Chevron appreciates the opportunity to respond to the questions raised in the Air Resources Board whitepaper *Staff's Preliminary Assessment of the Need for Clarification for the Reporting of Covered Product Data for Petroleum and Natural Gas* dated December 11, 2015. The white paper introduces a number of questions regarding reporting covered product data and ARB's assessment that variability exists in the reporting and metering methods used for thermal enhanced oil recovery (EOR) and non-thermal EOR covered product data under its Mandatory Reporting Regulation as required by the California Global Warming Solutions Act.

Attachment 1: Detailed Comments on the ARB Upstream Reporting White Paper

OIL VISCOSITY VS TEMPERATURE

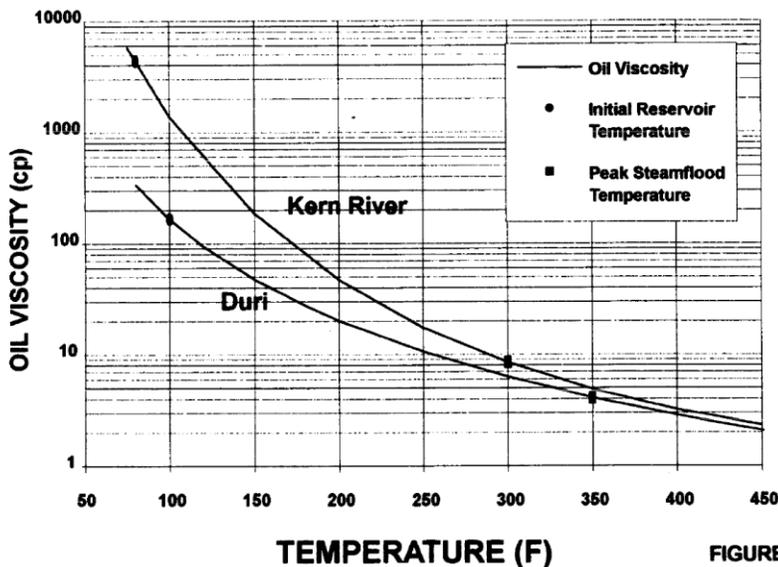
While Chevron supports continued use of ARB’s current definition of “thermal enhanced oil recovery” as the process of using injected steam to increase oil recovery, guidance can be further clarified by recognizing the injected steam’s function and purpose, which is to introduce heat. The added heat reduces the viscosity of the crude, making it easier to bring it to the surface.
